Docket Number:	16-AFC-01C
Project Title:	Stanton Energy Reliability Center - Compliance
TN #:	230521
Document Title:	STATEMENT OF STAFF APPROVAL OF PROPOSED CHANGE
Description:	Notice of Decision
Filer:	Raquel Rodriguez
Organization:	California Energy Commission
Submitter Role:	Commission Staff
Submission Date:	11/6/2019 2:44:10 PM
Docketed Date:	11/6/2019

STATEMENT OF STAFF APPROVAL OF PROPOSED CHANGE STANTON ENERGY RELIABILITY CENTER (16-AFC-01C)

SUMMARY OF PROPOSED CHANGES

ENVIRONMENTAL JUSTICE - FIGURE 2

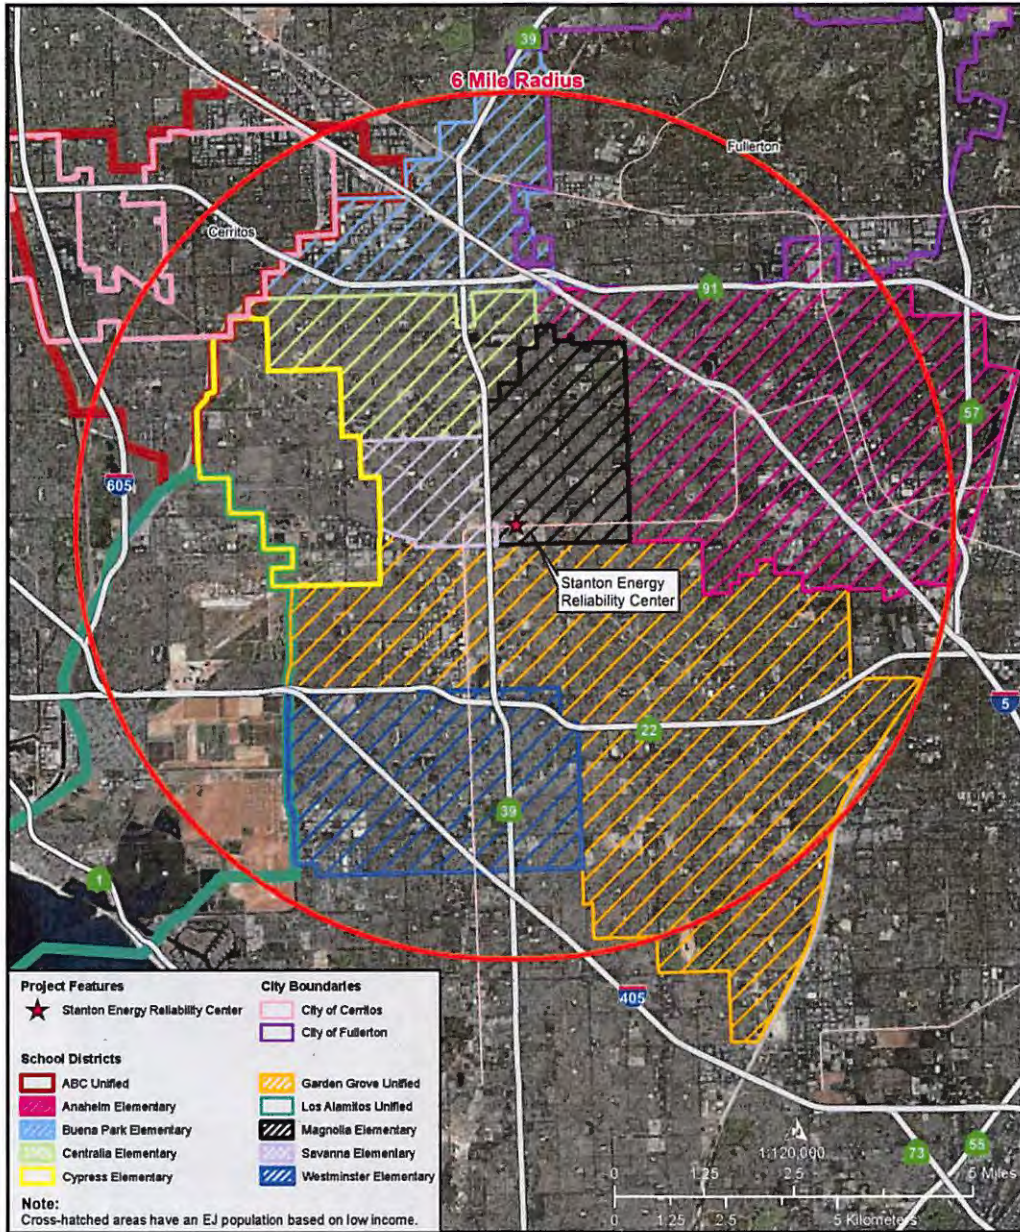
Environmental Justice – Figure 2 shows where the boundaries of the school districts and cities are in relation to the six-mile radius around the SERC site.

For the potential impacts to Air Quality, staff concludes that impacts would be less than significant, and thus would be less than significant on the EJ population represented in **Environmental Justice – Figure 1, Figure 2, and Table 1.**
